SLIM CHICKENS SITE PLAN

TOWN OF PARKER PLAN REVIEW

SITE PLAN
SLIM CHICKENS
COVER SHEET
SVC OF S. PARKER ROAD AND E. PINE LANE, PARKER, CO 80134

SITE PLAN
SLIM CHICKENS
 SWC OF S. PARKER ROAD AND E. PINE LANE, PARKER, CO 80134
SITE PLAN

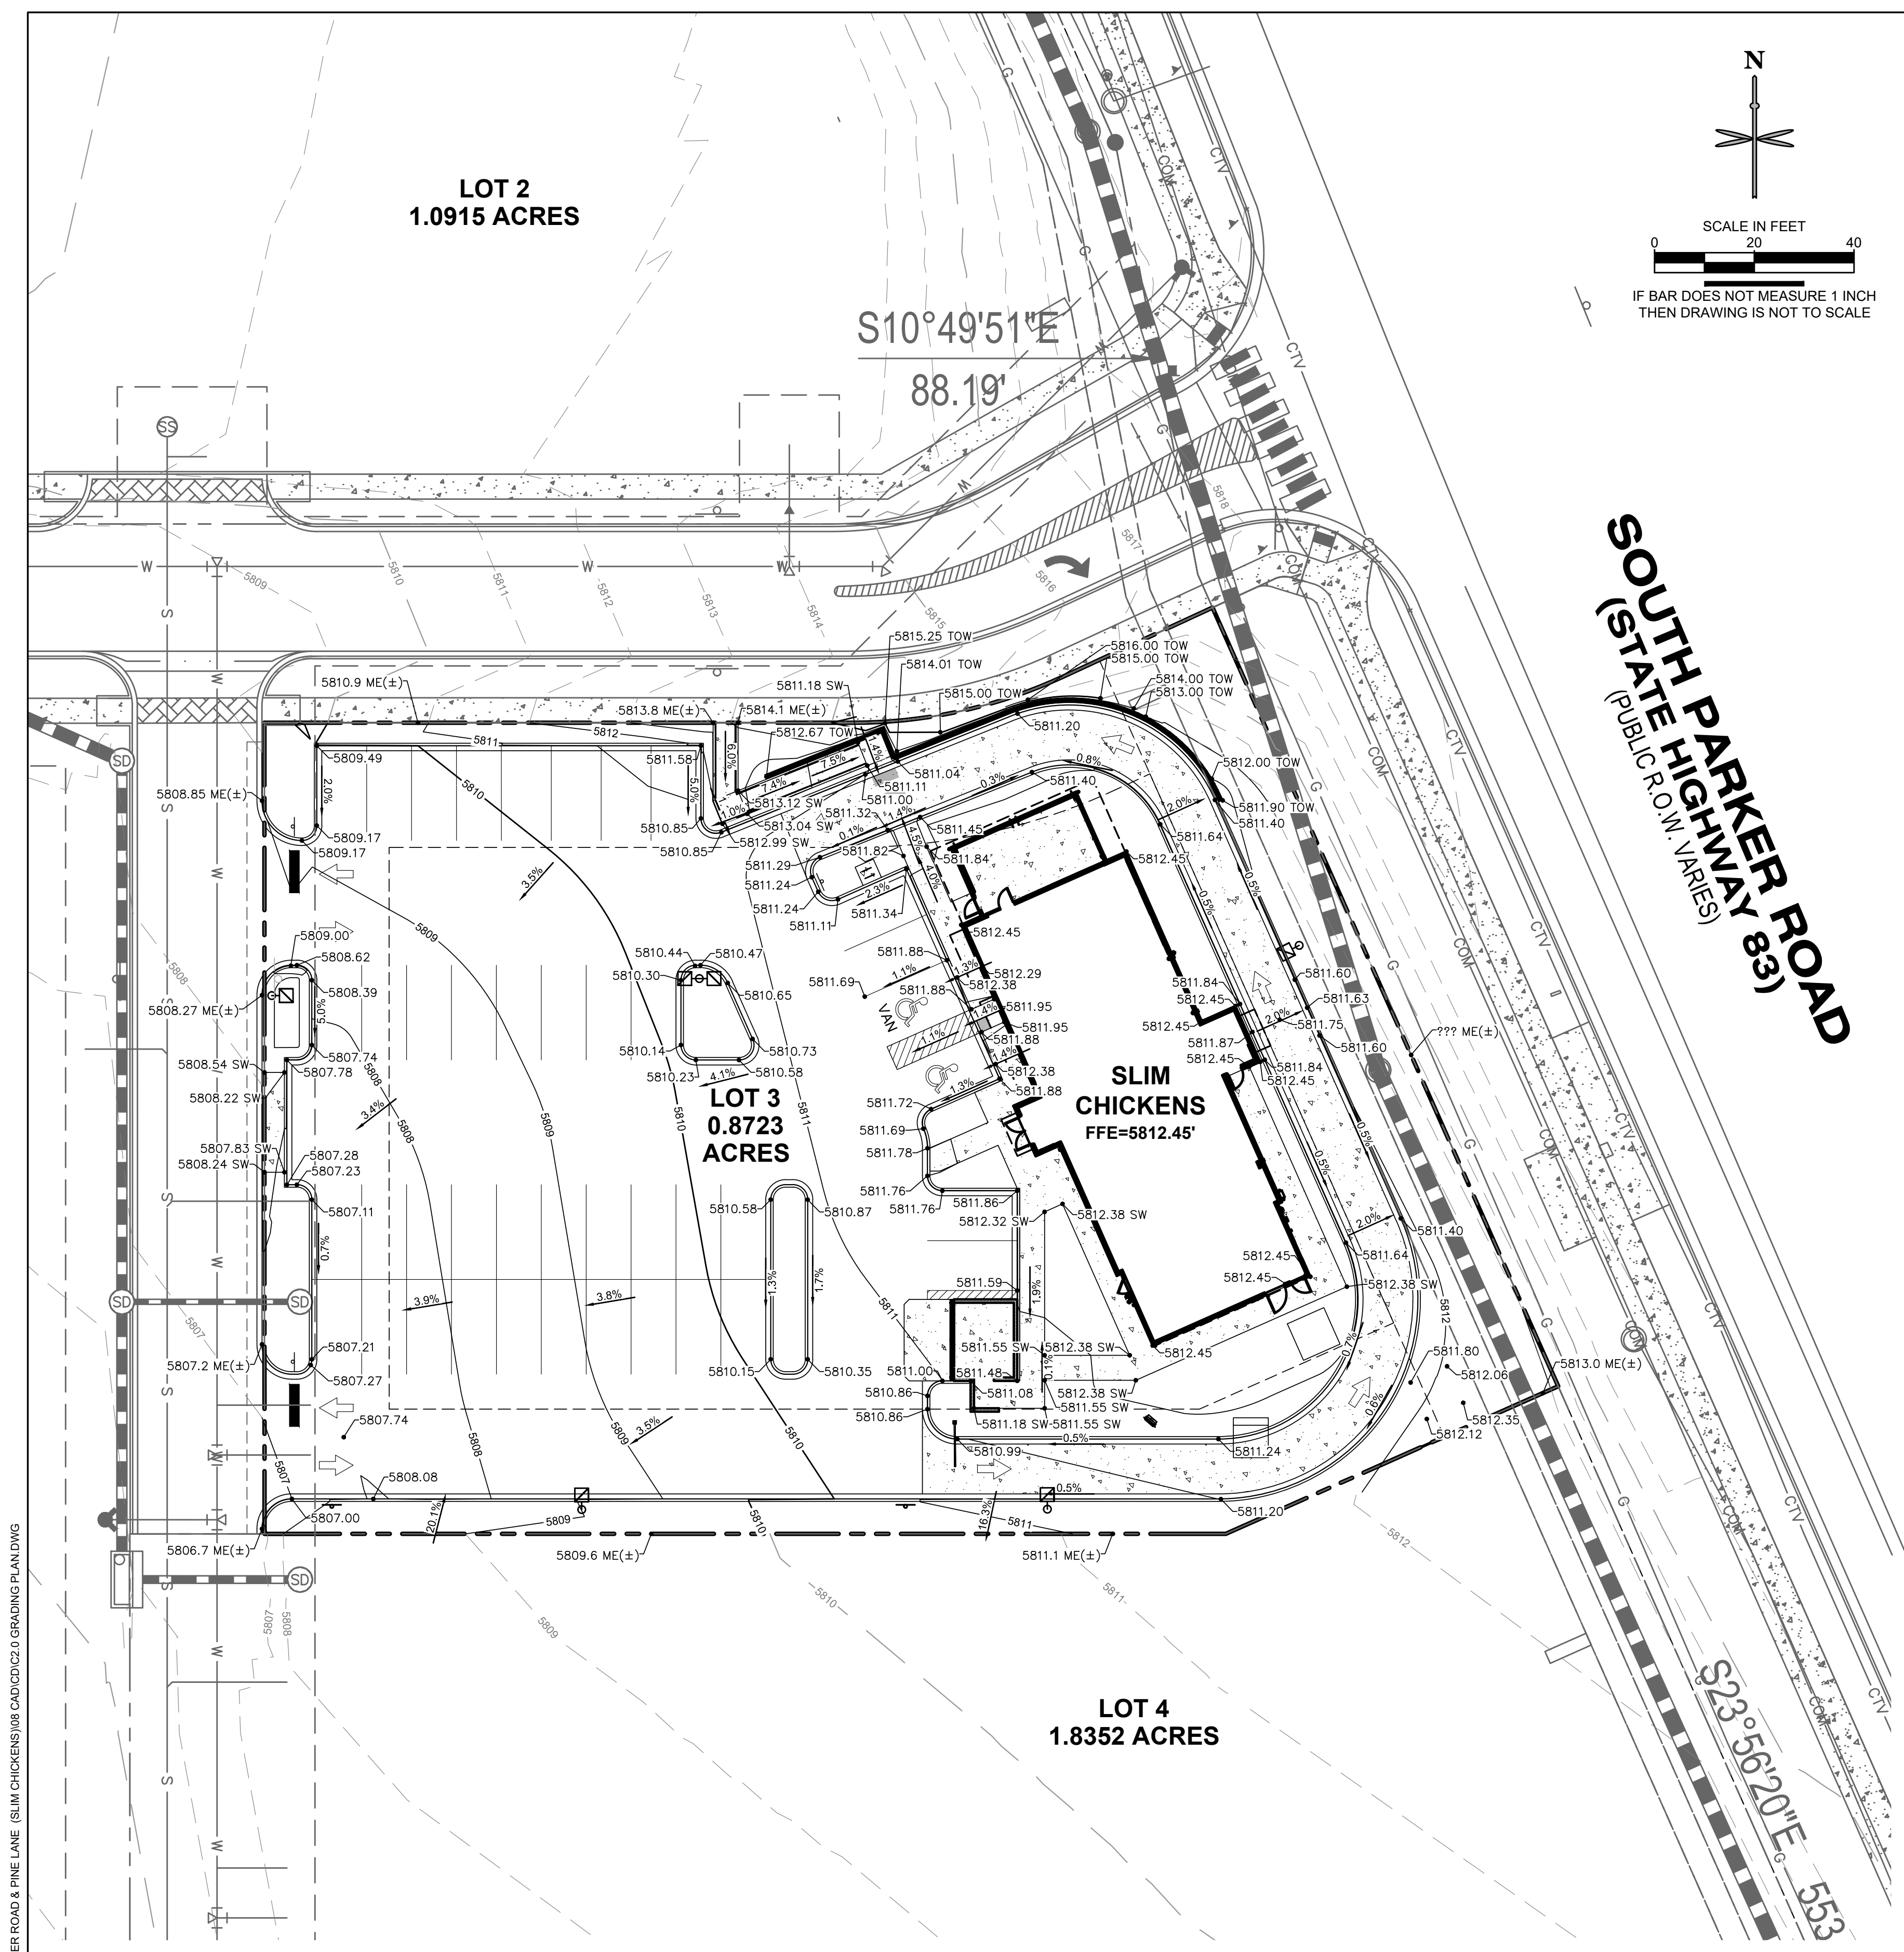
- Section 13.06.060 requires (4) bicycle parking spaces. Please add minimum (2) 2-bike facilities.
 - Please generally hatch landscape areas to distinguish between blank white areas from concrete or asphalted areas.

Remove note #2. New 8' sidewalk to be constructed along Parker Road side as a part of this site plan (per previous subdivision process). There is no existing sidewalk internal to existing site. See further comments regarding the Parker Road sidewalk in the Landscape Plan.

- 19 PROPOSED CONCRETE SIDEWALK Are there separate plans for the clearance bar? If so, please provide P5.1 in this set
- 20 PROPOSED CONCRETE PAVEMENT
- 21 PROPOSED ASPHALT PAVEMENT

We hatched pavement. Refer to Landscape Plans.

SITE PLAN
SLIM CHICKENS
 SWC OF S. PARKER ROAD AND E. PINE LANE, PARKER, CO 80134
PLANTING PLAN

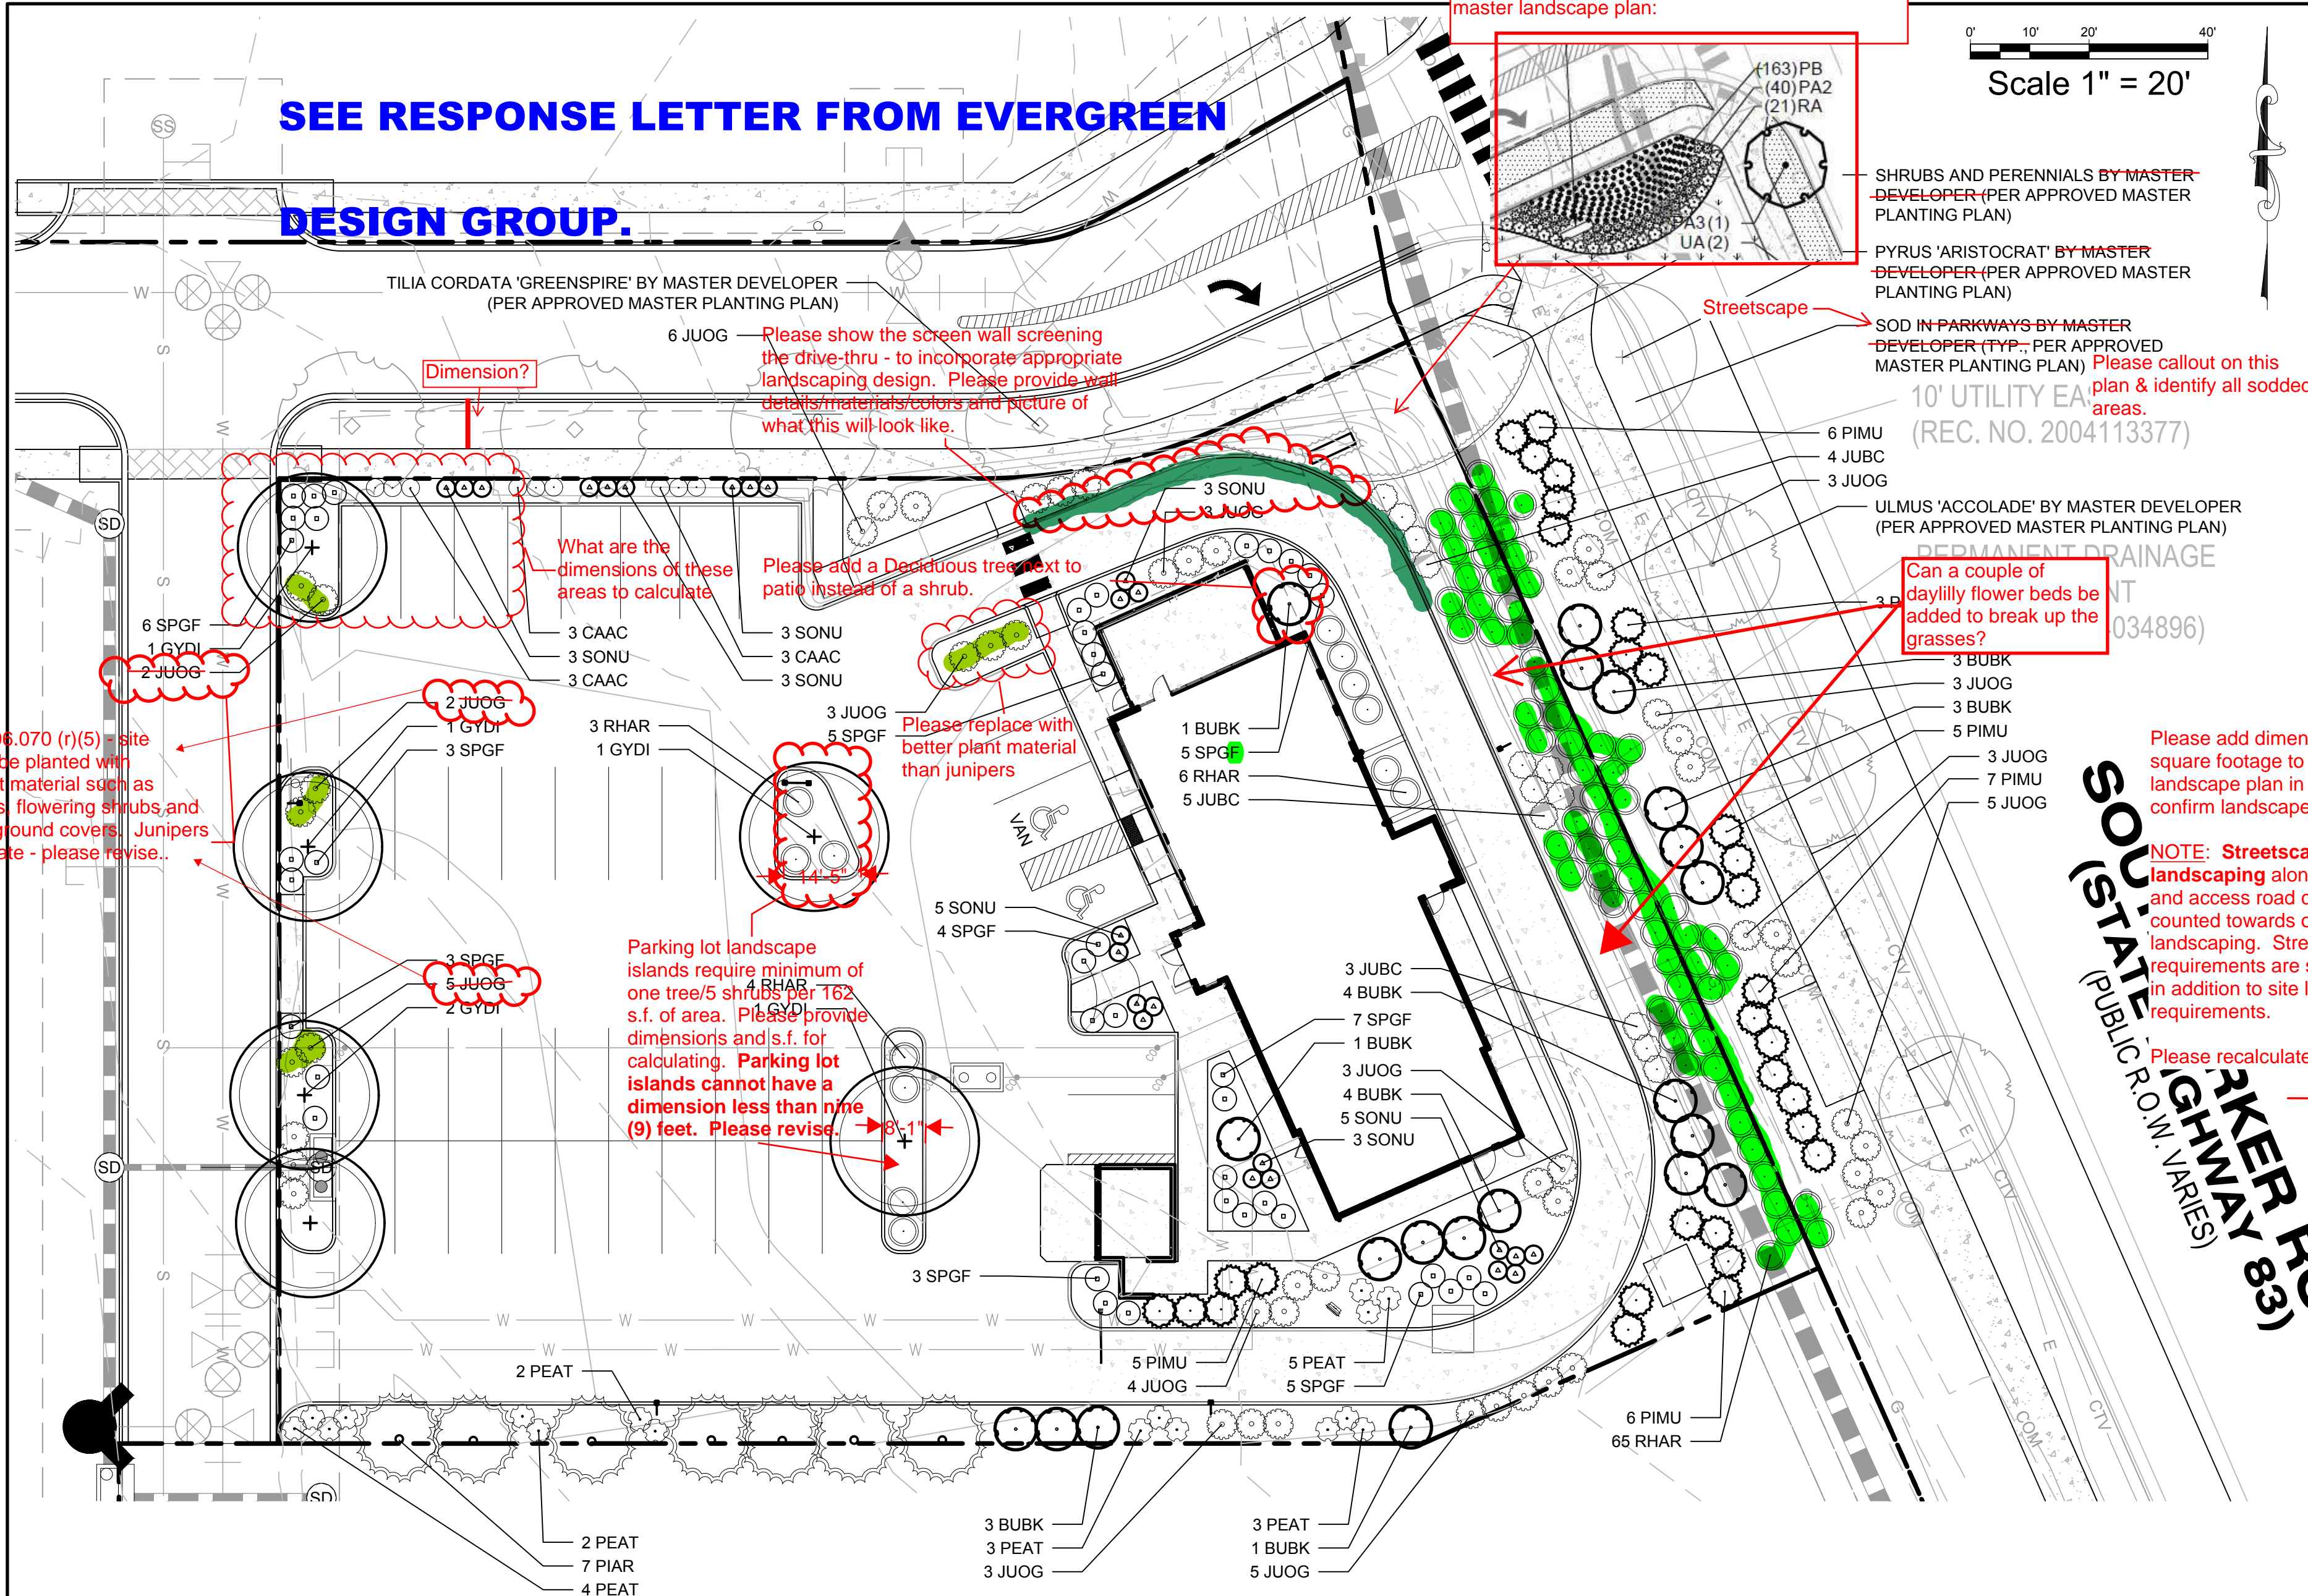
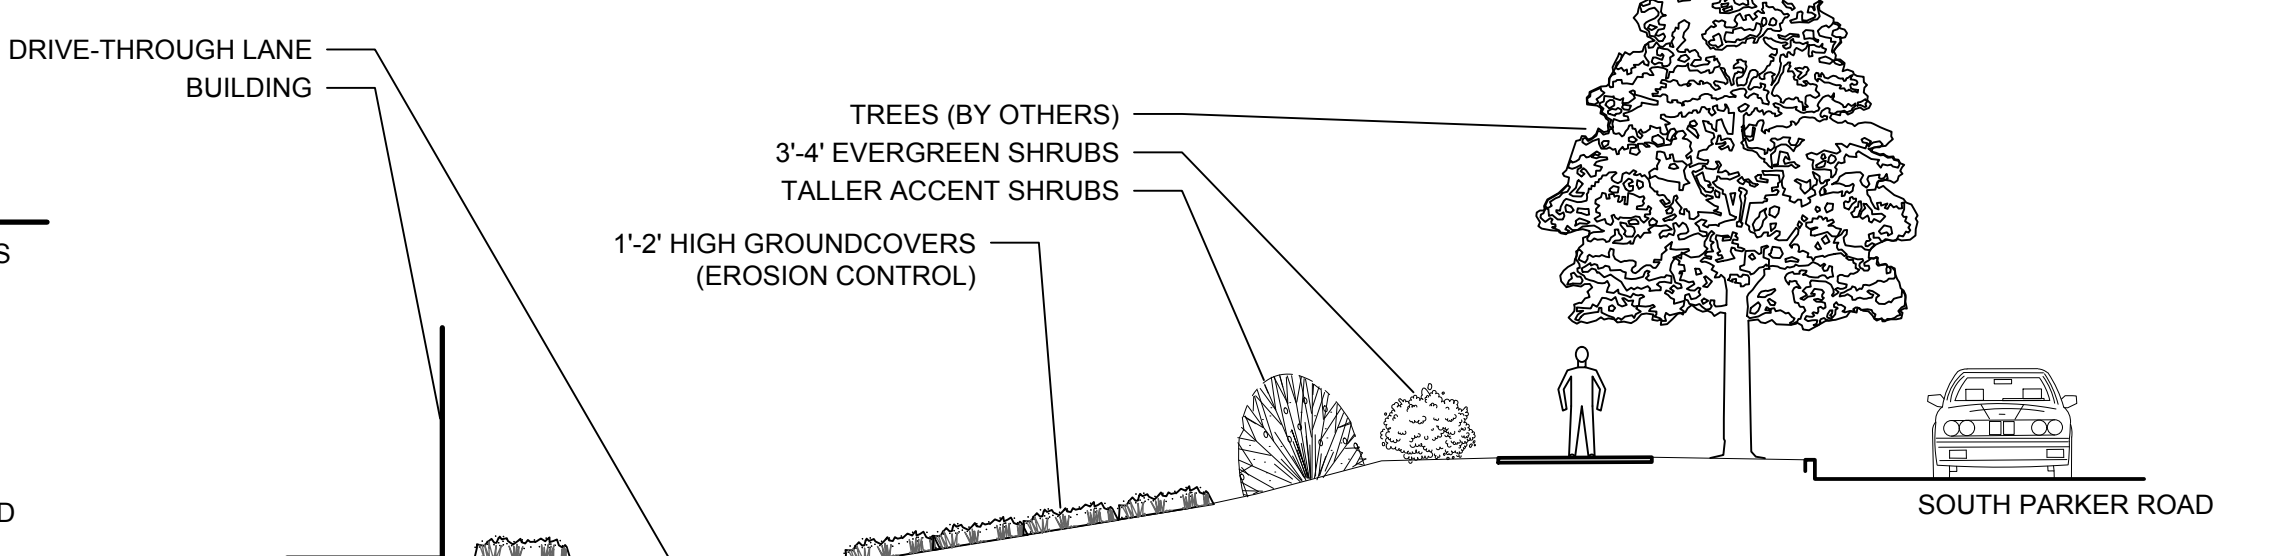
Please incorporate the approved 'enhanced corner landscaping' - Sump provided from the approved master landscape plan:

Pursuant to 13.06.070 (r)(5) site entryways shall be planted with ornamental plant material such as ornamental trees, flowering shrubs, and perennials and ground covers. Junipers are not appropriate - please revise.

Please show the screen wall screening the drive-thru - to incorporate appropriate landscaping design. Please provide wall details/materials/colors and picture of what this will look like.

Please add a Deciduous tree next to patio instead of a shrub.

Please replace with better plant material than junipers

Parking lot landscape islands require minimum of one tree/5 shrubs per 100 s.f. of area. Please provide dimensions and s.f. for calculating. Parking lot islands cannot have a dimension less than nine (9) feet. Please revise.

SOD IN PARKWAYS BY MASTER DEVELOPER (PER APPROVED MASTER PLANTING PLAN) Please callout on this plan & identify all sodded areas. (REC. NO. 2004113377)

Can a couple of daylily flower beds be added to break up the grasses?

Please add dimensions and square footage to site plan or landscape plan in order to confirm landscape calcs.

Please add Streetscape Landscape

Please identify all of these (areas & dimensions on the plan for staff to confirm calculations.

Need to provide the additional tree on site. Recommending Eastern Frontage at patio instead of shrub.

5 gallon required. Please revise.

Divide in half & add another variety for interest

SEE RESPONSE LETTER FROM EVERGREEN
